PROCESS CHANGE NOTIFICATION

Product Identification: SI-5, SI-8 series

Unique Tracking Number: PCN NO, PC208672

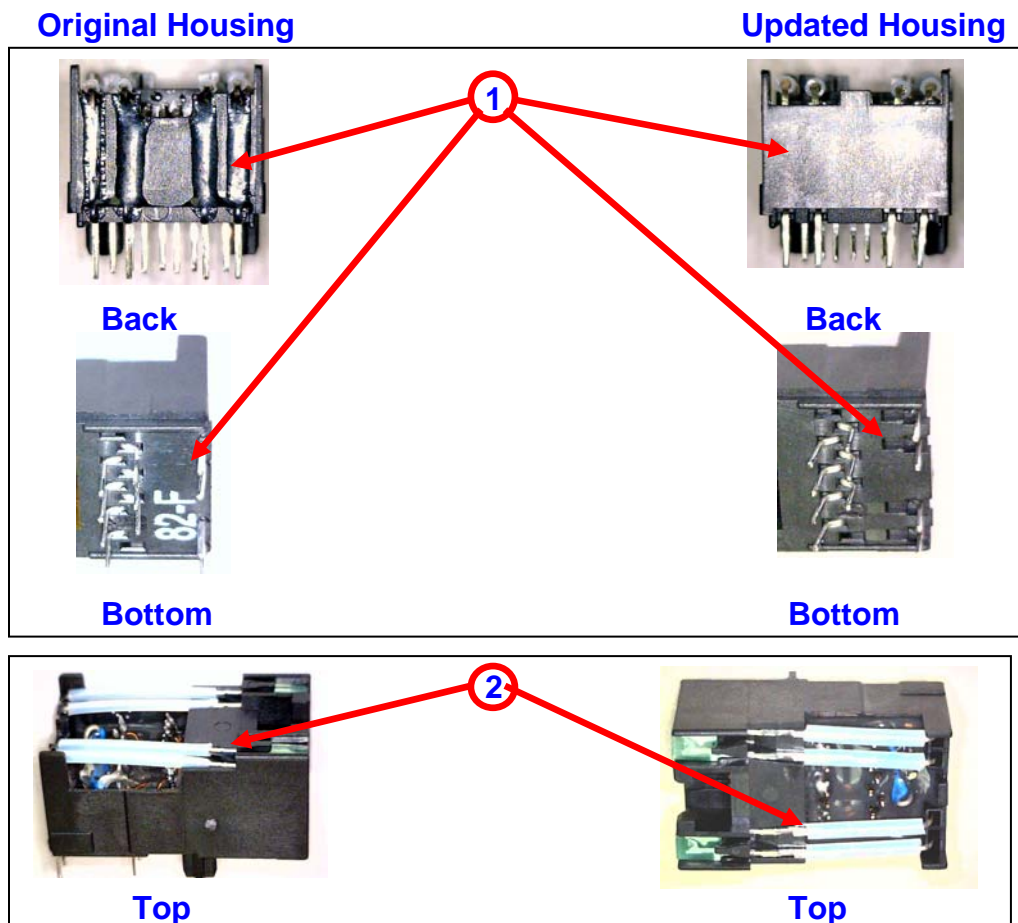
Reason(s) for Change: In an effort to continually improve our product, Bel is pleased to announce that the design of these Integrated Connector Product series is being updated.

1. We are removing epoxy operation and placing plastic walls between the LED leads to better insulate them from the shield and magnetics.
2. We are modifying the length of the insulating tubing so it is secured between the two walls of the housing to ease assembly.
